WATER PERMIT NO. 6086-3

SOUTH DAKOTA
WATER PERMIT NO. 6086-3

REPORT ON
WATER PERMIT APPLICATION NO. 6086-3
Art Geyer
June 23, 1998

EARTH DAM

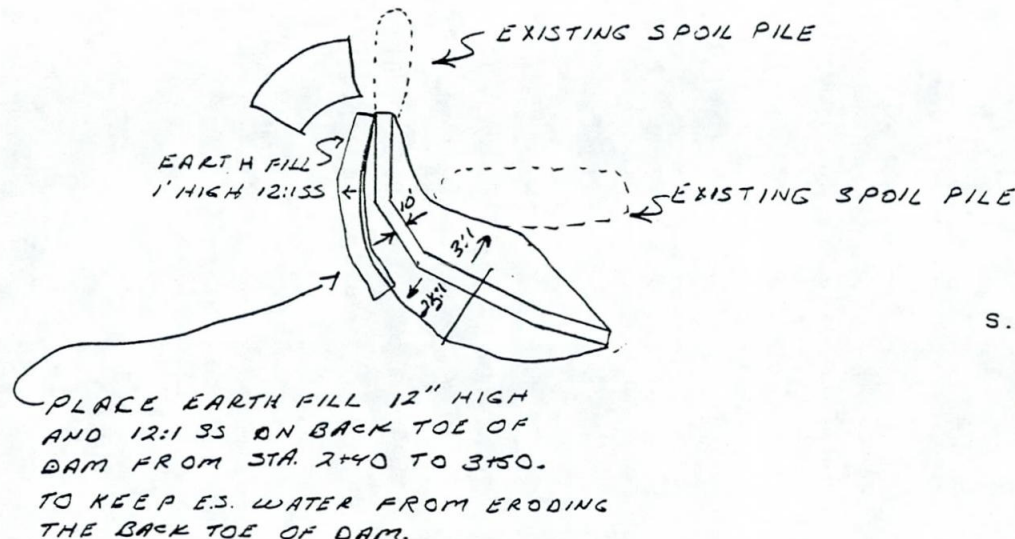
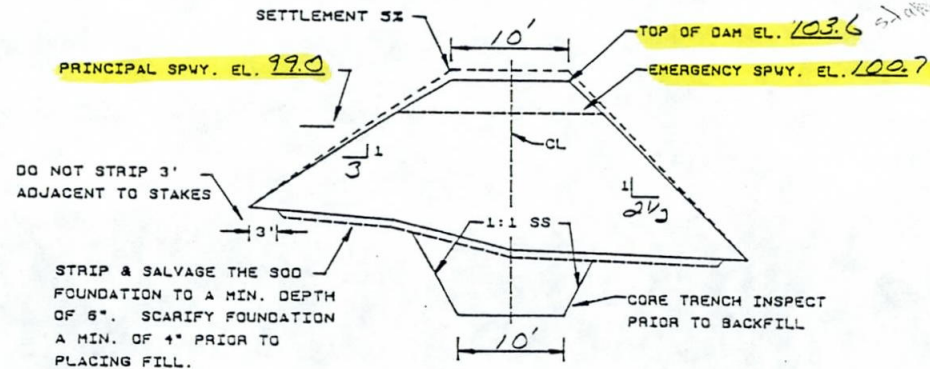
Section 74:02:08:09

1. - Topo Map - OK
2. - Dam Axis Profile - OK
3. - Dam Max X-Sec - OK
4. - Area Capacity Data - OK
5. - Outlet Details - OK
6. - Spillway Rating - OK
7. - Spillway Details - OK
8. - Specs. - Std. NRCS - OK
9. - EPP - N/A Cat. 3 - OK
